Accepted Drainage Proposal under Previous Application No. A/YL-NTM/456

Compliance with Approval Condition (a)
Submission of a Drainage Proposal

**Proposed Temporary Shop and Services for a Period of 5 Years
in "Recreation" Zone, Lot 630 (Part) in D.D. 104, Ngau Tam Mei, Yuen Long
(Planning Application No. A/YL-NTM/456)**

Stormwater Drainage Proposal Report

PLAN D02 - PROPOSED DRAINAGE PLAN

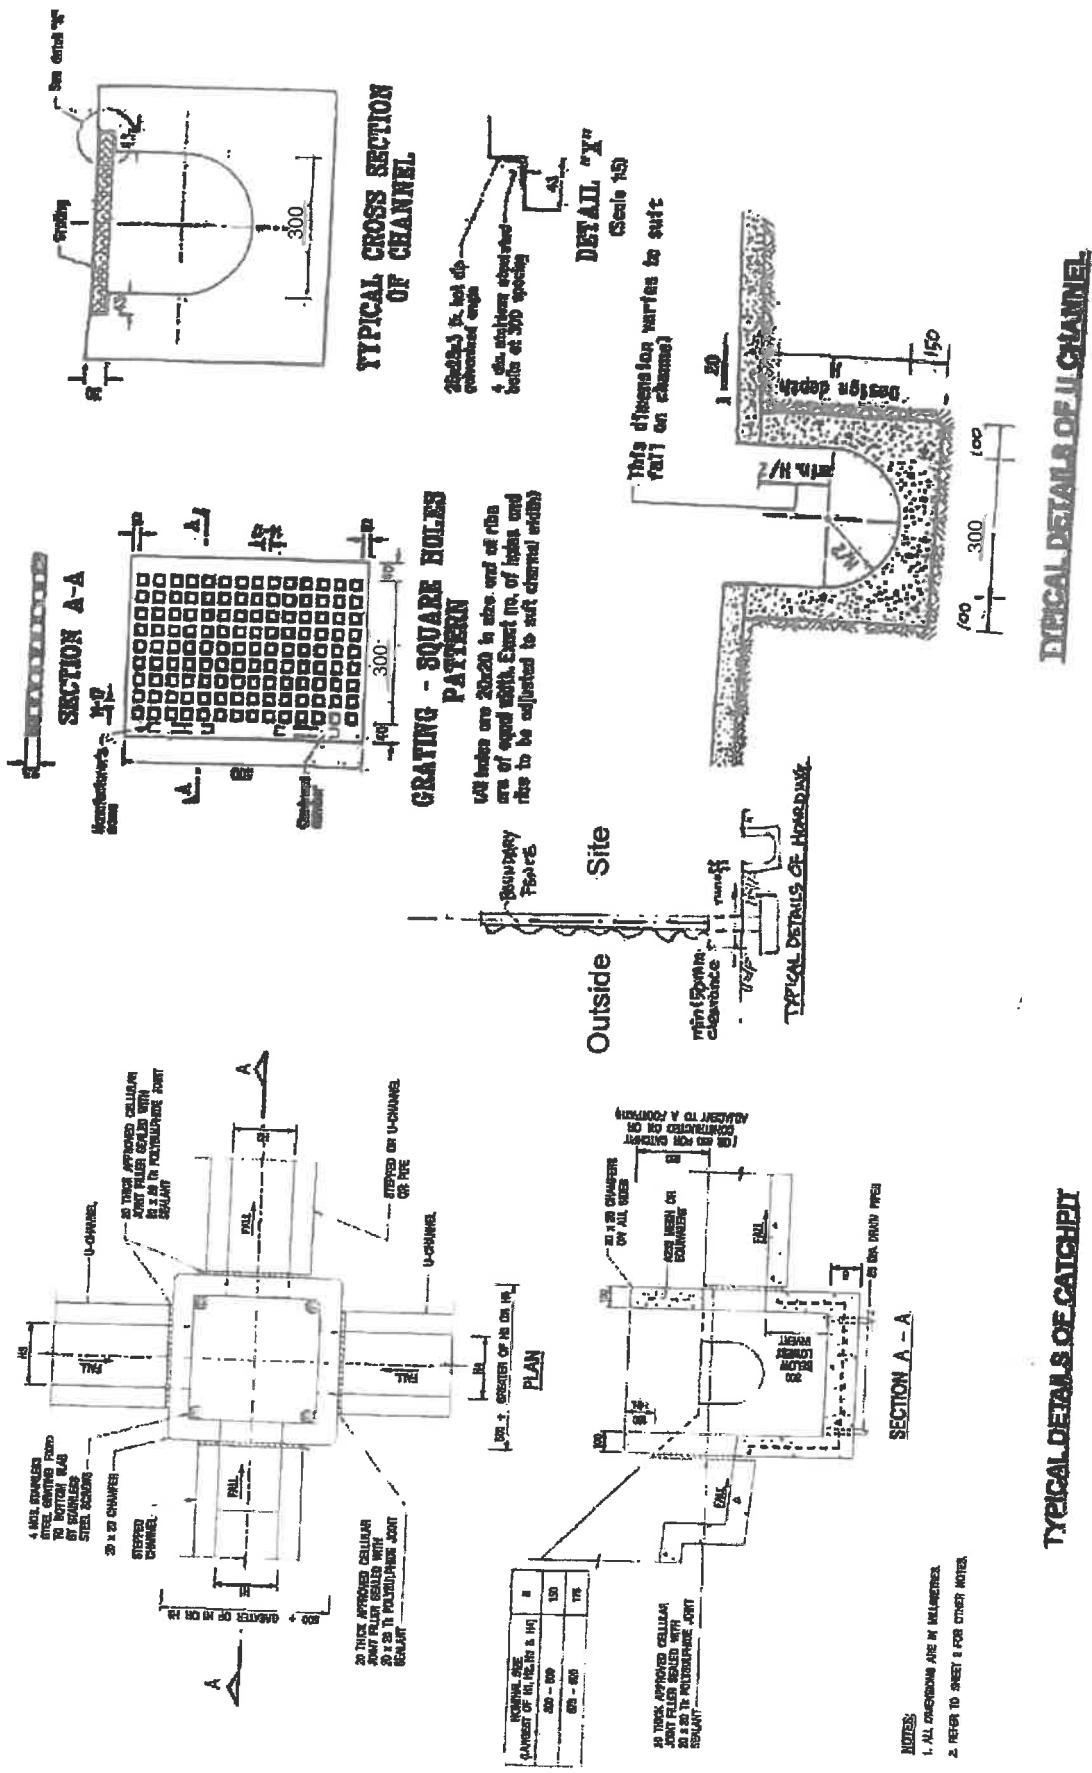
Comments	Response
1. In western peripheral channel calculation: The eastern catchment flow should also be considered in the western peripheral channel assessment	Noted. The design calculation has been revised to include the eastern catchment flow in designing the western peripheral channel. The size of the channel is revised from 225 to 300mm UC

Figure 4a – Intensity-Duration-Frequency Curves of HKO Headquarters
(for durations not exceeding 4 hours)

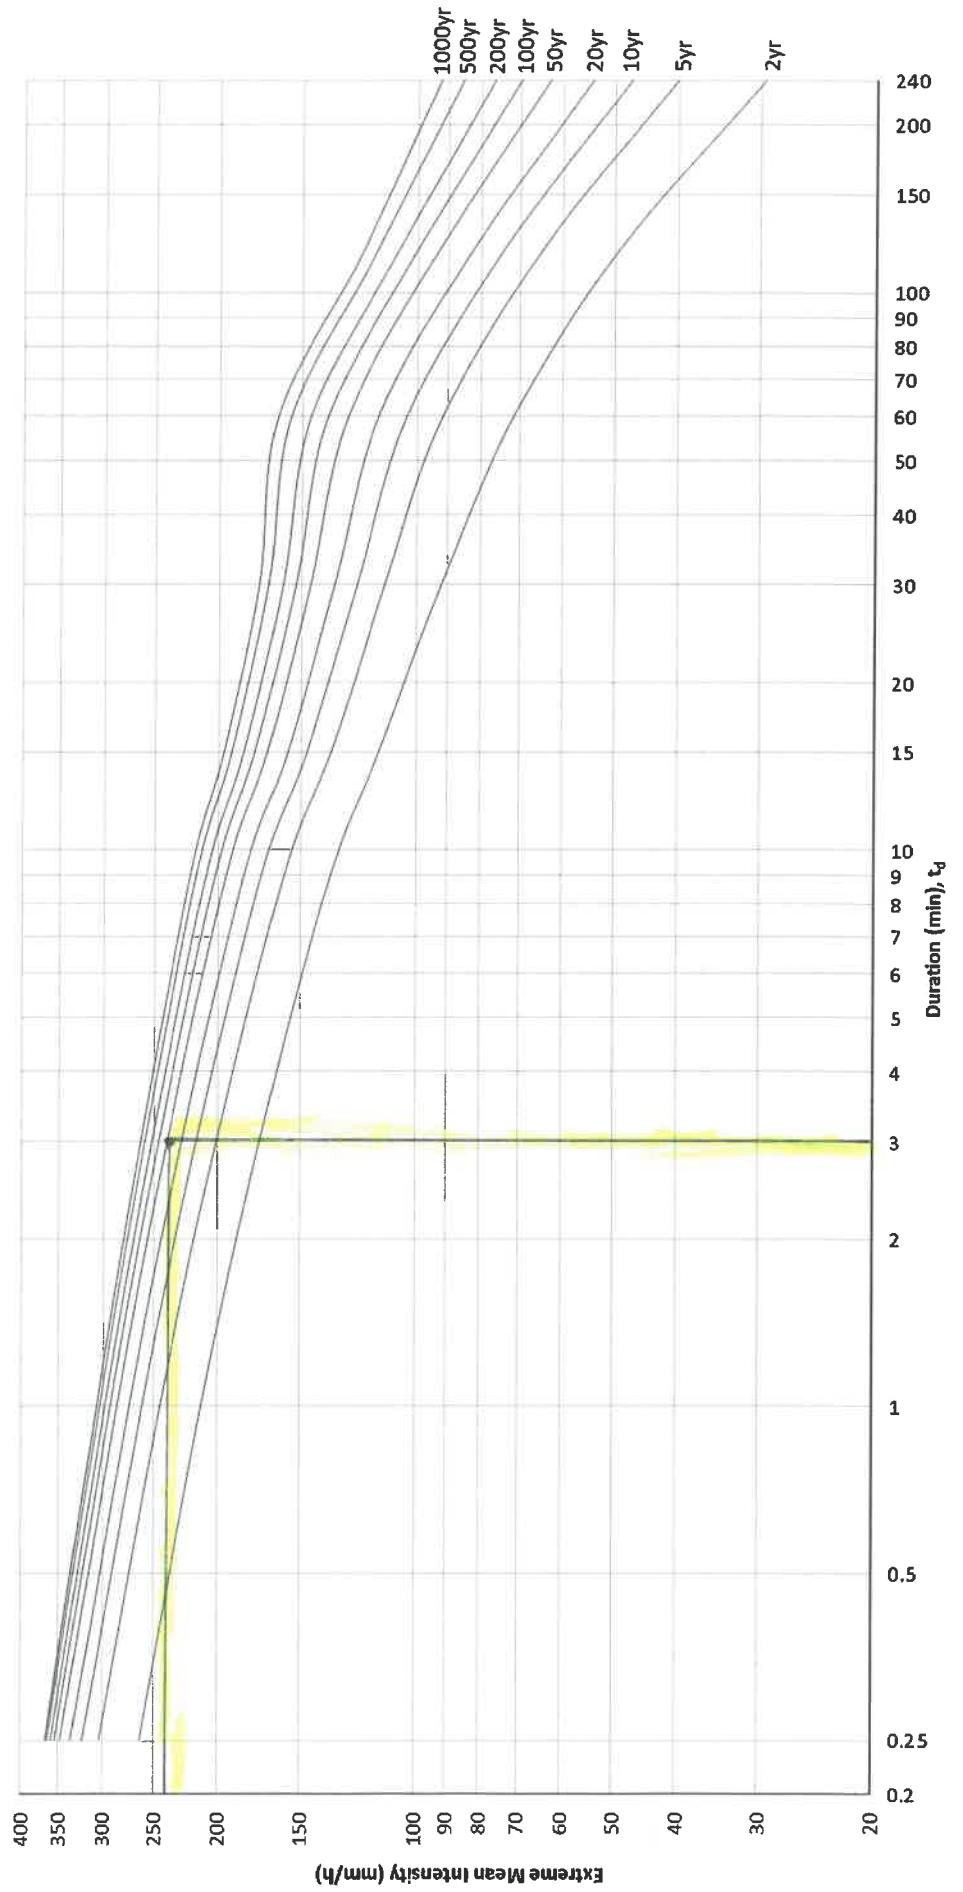
3. Please also clearly indicate the designed lines in the charts (i.e. Figure 4a and 8.7) provided,	Noted. The designed lines were shown in the charts for reference.

From Figure 4a of Stormwater Design Manual , i = 240 mm/hr
